NINE MILE POINT NUCLEAR STATION UNIT NO. 1

AMENDMENT TO FACILITY OPERATING LICENSE

Amendment No. 131 License No. DPR-63

ATTACHMENT TO LICENSE AMENDMENT AMENDMENT NO. 131 TO FACILITY OPERATING LICENSE NO. DPR-63

FIGURE 2.1.1

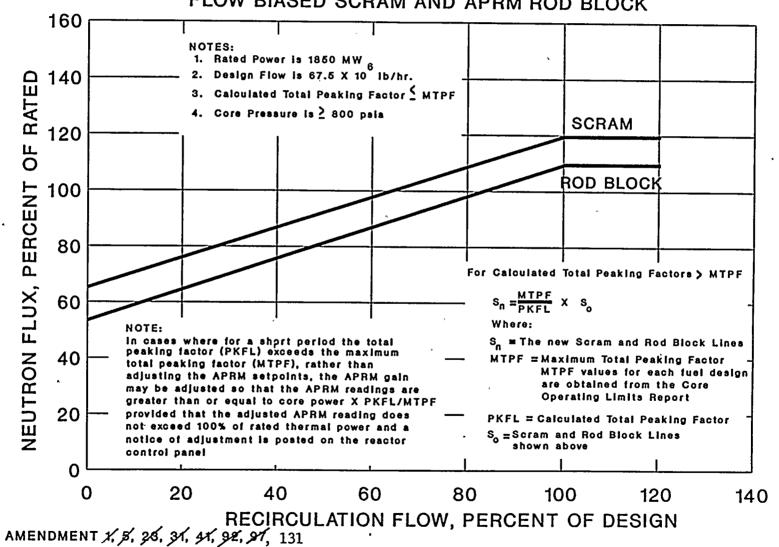
In addition to the boiling transition limit SLCPR, operation is constrained to a maximum LHGR as specified in the Core Operating Limits Report. At 100% power, this limit is reached at a given Maximum Total Peaking Factor (MTPF). The value of MTPF for each fuel design is contained in the Core Operating Limits Report. During steady-state operation where the Calculated Total Peaking Factor (PKFL) is above the MTPF, the equation on Figure 2.1.1 will be used to adjust the flow biased scram and APRM rod block setpoints.
